**ADDENDUM NO. ONE (1)**  
TO THE DRAWINGS AND SPECIFICATIONS FOR

**NEW CLASSROOM / TORNADO SHELTER ADDITION FOR  
BENTON HIGH SCHOOL**  
449 Fairburn Drive  
Bossier City, Louisiana 71112

BPSB Project No. 26-02  
BA Project No. 2511

27 February 2026

**01** DIMENSION FLOOR PLAN  
A2.1 SCALE: 1/8" = 1'-0"

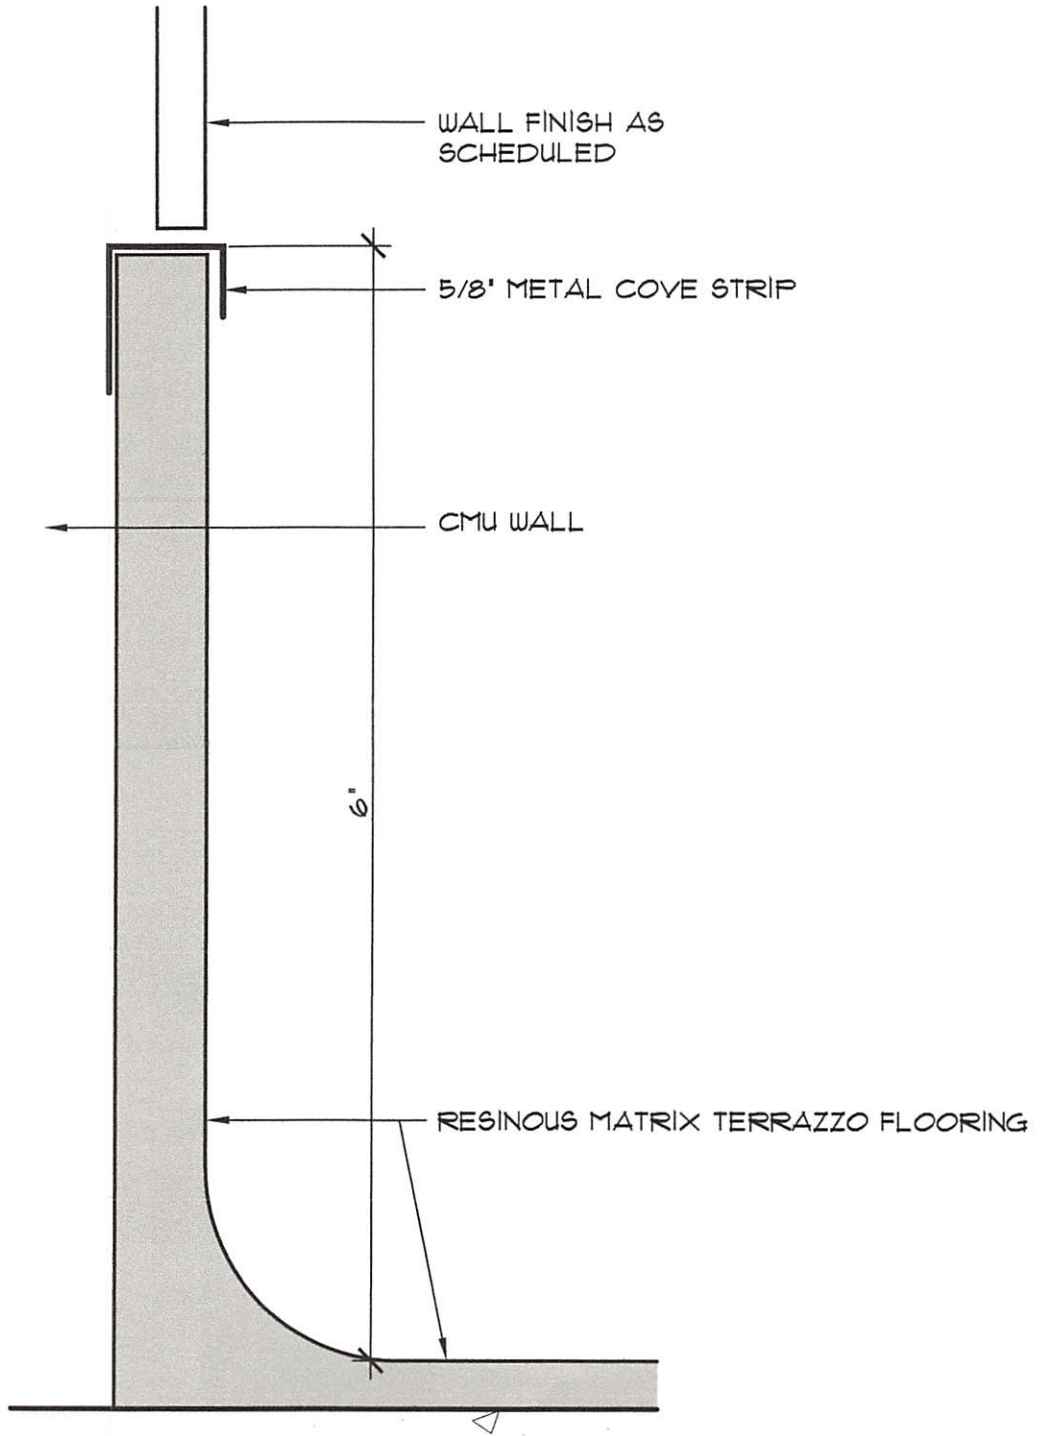
**Item 15. Drawings Sheet A2.1, 01 DIMENSION FLOOR PLAN:**

Corridor “H101” dimensions have be modified to reflect the change in the HVAC closet door sizes. See Item #11.” The revised sheet A2.1 is attached.
